# Gulfstream G450

## **AIRCRAFT SERVICE CHANGE**

NUMBER 059B

NAVIGATION (ATA 34)

FIGURE 1 (4001 – 4193)

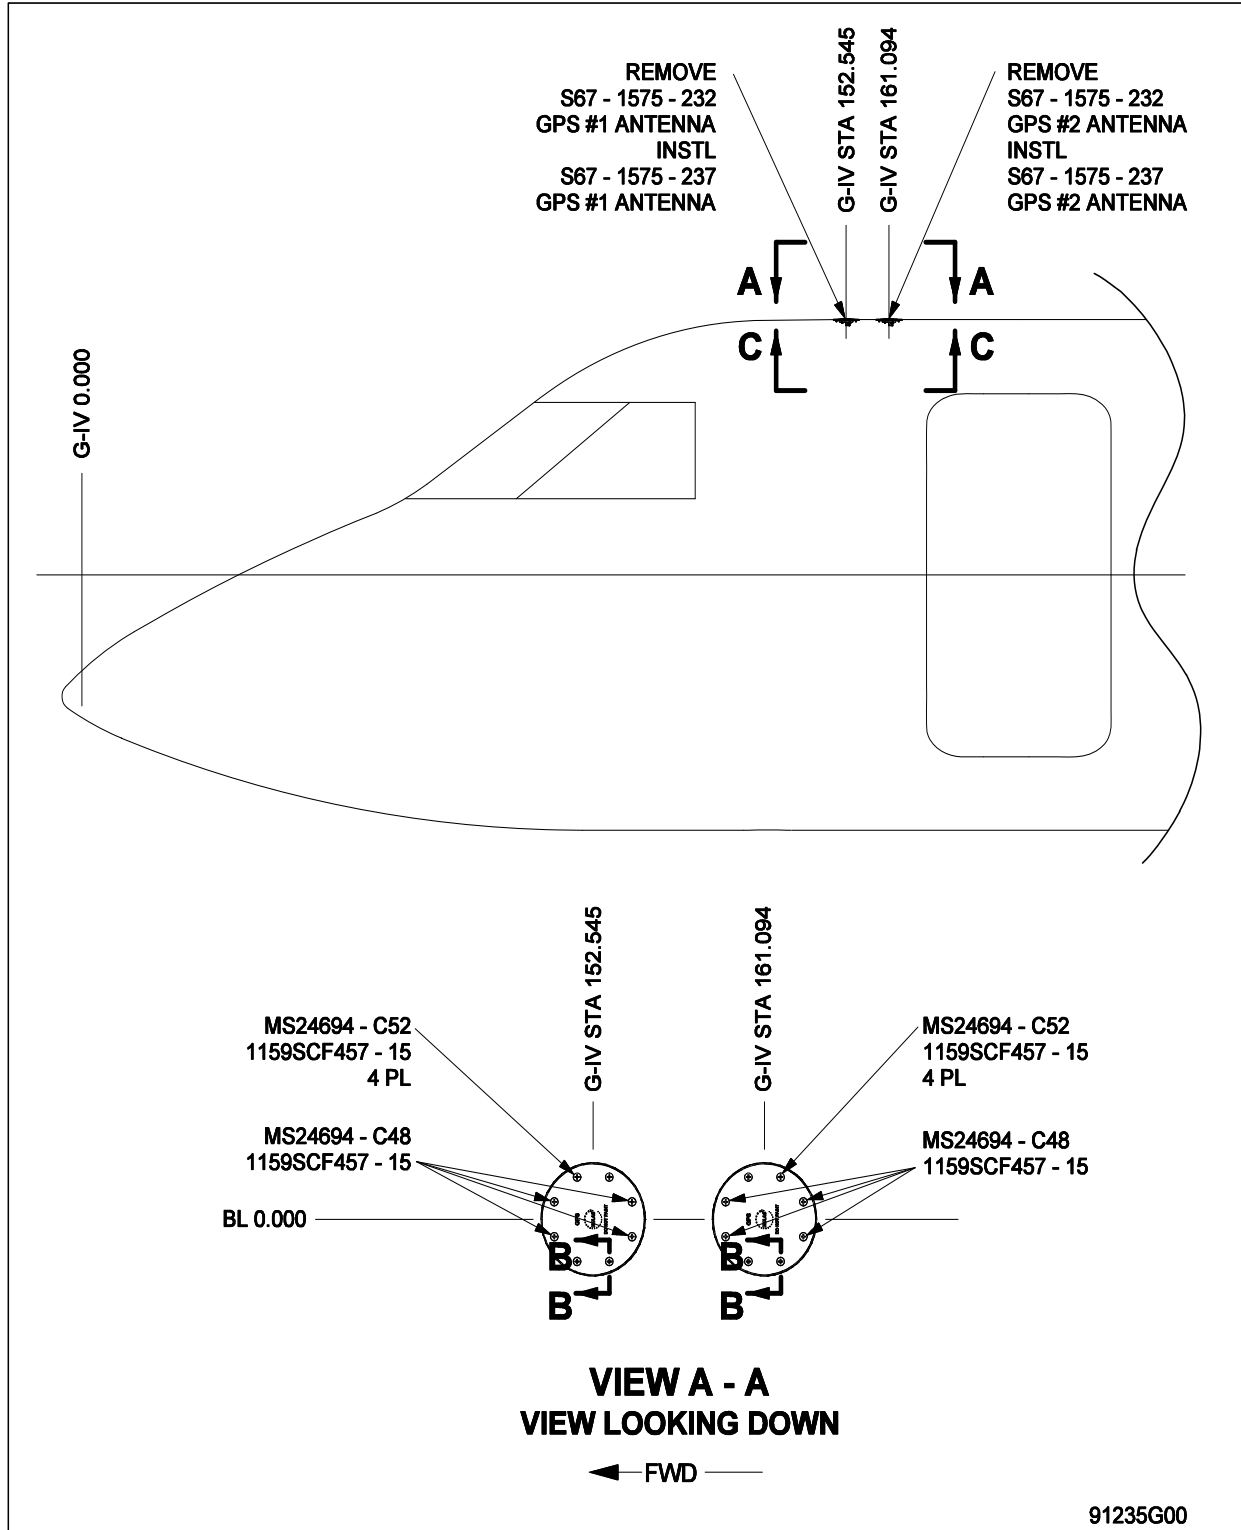
4. Gain access to GPS antennas located in the over head area forward of the main entry door (MED) on aircraft serial numbers 4001 - 4193. Refer to G450 AMM, Chapter 34 and Figure 1.
5. Remove existing GPS antennas, PN S67-1575-232. Hardware may be retained and reused or replaced. Refer to Figure 1.

6. Install new GPS antennas, PN S67-1575-237, and gaskets, PN GAG810GG1-9, using screws, PN MS24694-C48 and MS24694-C52. Orient antennas so the right angle connectors point towards the rear of the aircraft. Ensure appropriate hardware is utilized in correct location. Refer to Figures 1 and 2.

FIGURE 2 (4001 - 4193)

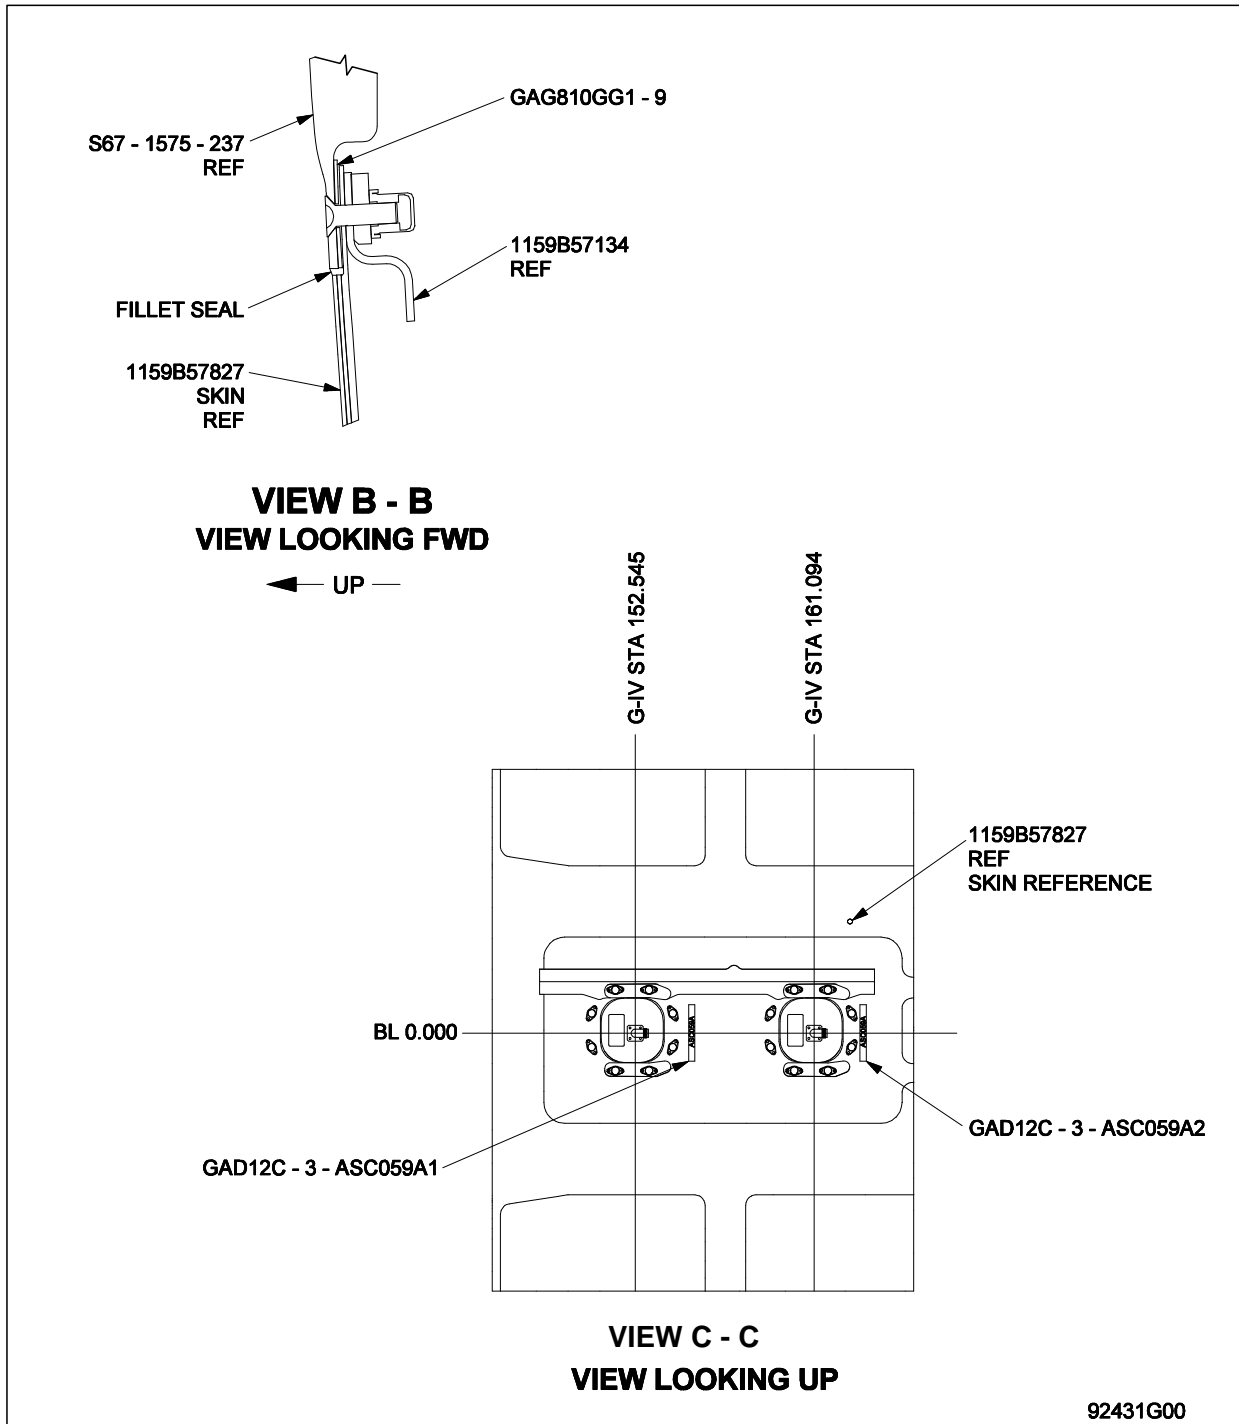
10. Locate decals approximately as shown in Figure 2, view C-C. Overcoat with clear epoxy top-coat extending 1/8<sup>th</sup> inch beyond edge of decal. Remove any existing decals if necessary.
